From: Michaela Briggs <MBriggs1@cityofsydney.nsw.gov.au>
Sent: Thursday, 2 March 2017 11:24 AM
To: Andrew Hartcher
Subject: Public submission received regarding SSD 7689
Attachments: Review of Noise Impact Assessment .pdf; scan.pdf; 20170220151918591.pdf; pile condition grid layout_DRAFT 190412.pdf

WALSH BAY ARTS PRECINCT | STAGE 2 STATE SIGNIFICANT DEVELOPMENT APPLICATION

Peer review of noise and vibration impact assessment

TH720-02F01 Review of Noise Impact Assessment (r4)

Figure 2: Proposed construction vehicle entry and exit points and access for existing tenants

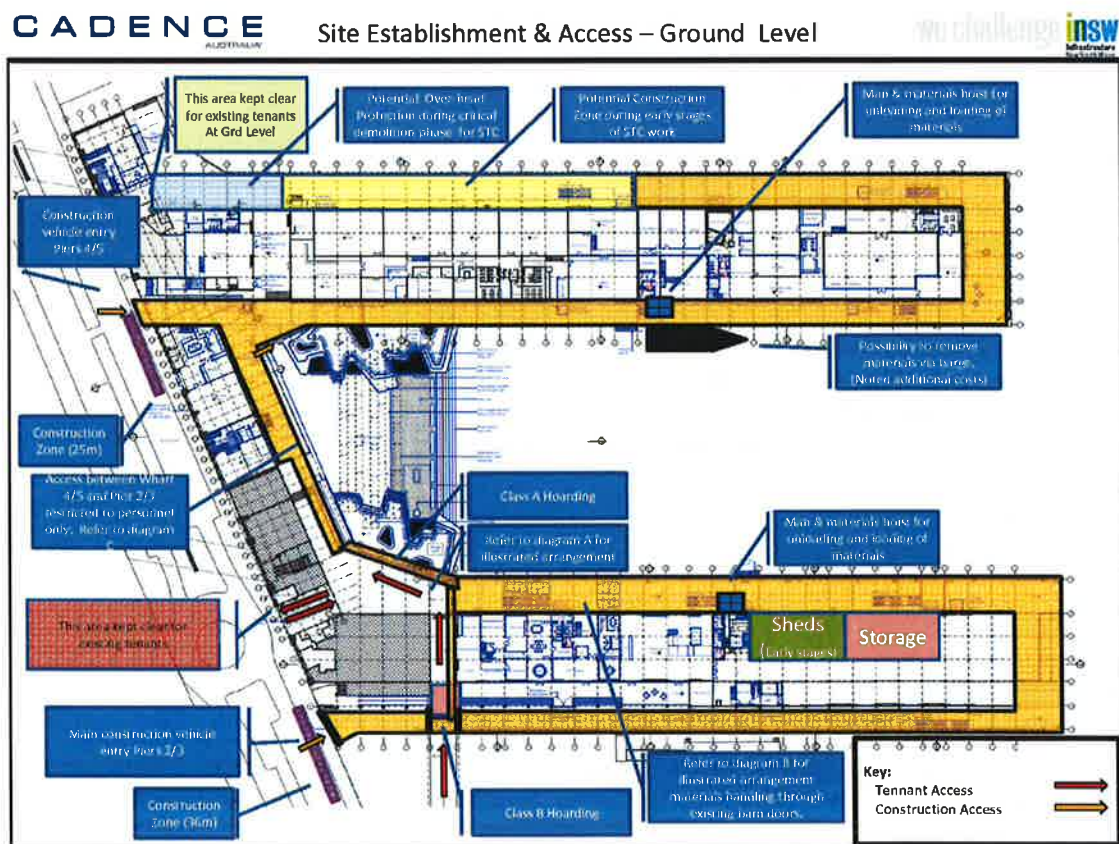
Figure 2 shows the proposed construction access arrangements. The two key construction entry and exit portals are via Pier2 and Wharf 4. The access from Hickson Road via Pier 3 is to be kept free for existing tenants (including SP 73989).

According to Section 6.4.7 of the Arup Report, there will be 40-80 vehicles per day (i.e. 80-160 vehicular movements per day) associated with deliveries and debris removal from the site. It is noted that the construction traffic corridor extends across both the north-west and the eastern facades of SP 73989. Noise impacts from truck traffic entering and leaving the site would therefore be a relevant matter to be addressed.
